PRODUCTION ANNOUNCEMENT

Milletechnik launches a new ECO 24V 1A Mini. The product is a compact 24 V battery backup for small security applications where easy installation and backup operation are required. At the same time, the ECO 12V 2A Mini is launched to complement the range with a demanded 12 V variant of the product.

The ECO 24V 1A Mini is introduced as a new product, it replaces the previous ECO Mini and has a new part number and a new e-number.

ECO mini

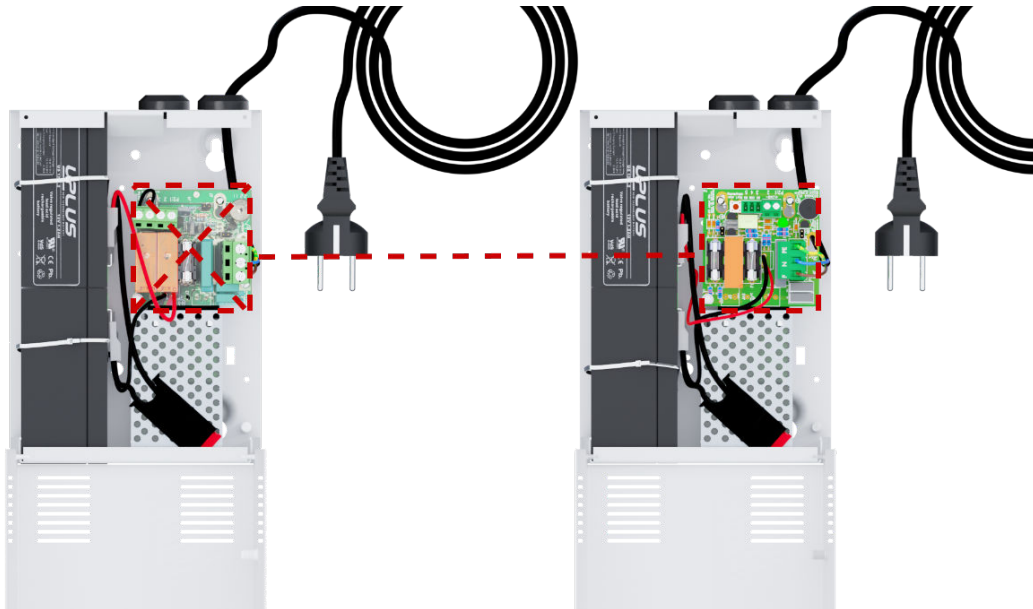
The purpose of the change is to update the product with a new design, clearer alarm and indication functions as well as a clearer delineation of the product's scope of use.

The new ECO 24V 1A Mini has updated design on the motherboard and changed functions compared to the previous ECO Mini.

The main difference is that the function of external load disconnection via switches is not present in the new product.

Therefore, customers who have previously used external load disconnection need to check whether the new ECO 24V 1A Mini fits the current installation. Need the function be referred to [EN54 24V 1.5A MX S](#).
